Rezoning Transportation Analysis

Petition Number: 2020-067

General Location Identifier: Tax ID 09505544

Date	Description
05-18-20	First Review
06-25-20	Second Review (TV)
08-25-20	Third review

Reference (CLDSM standard detail U-03A) for street typical.

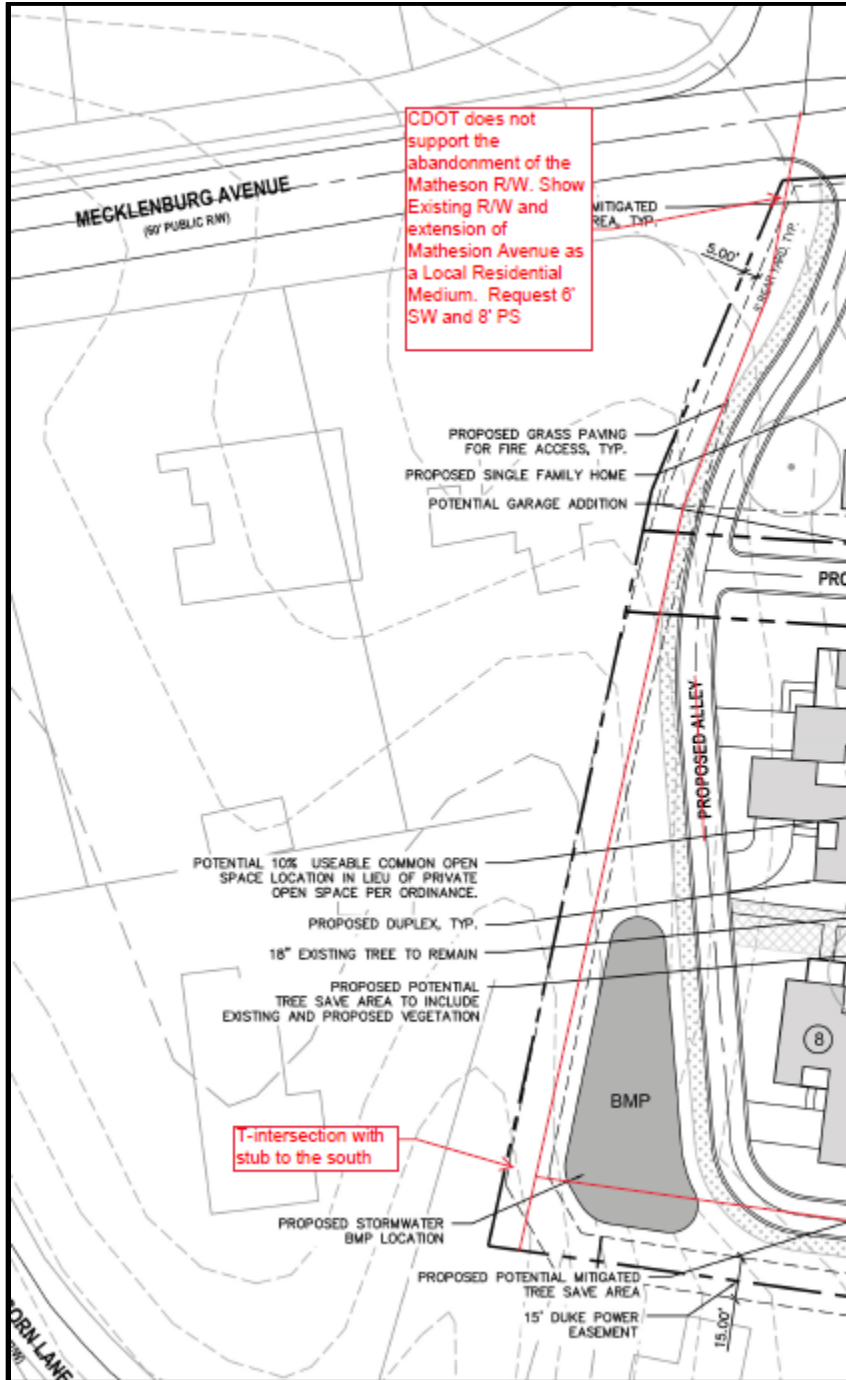
- The petitioner should revise the site plan and conditional note(s) to commit to constructing a public street, Matheson Avenue south of Mecklenburg Avenue, as a Local Residential Medium with an 8-foot planting strip, and 6-foot sidewalk per Chapter 20 Subdivision ordinance.
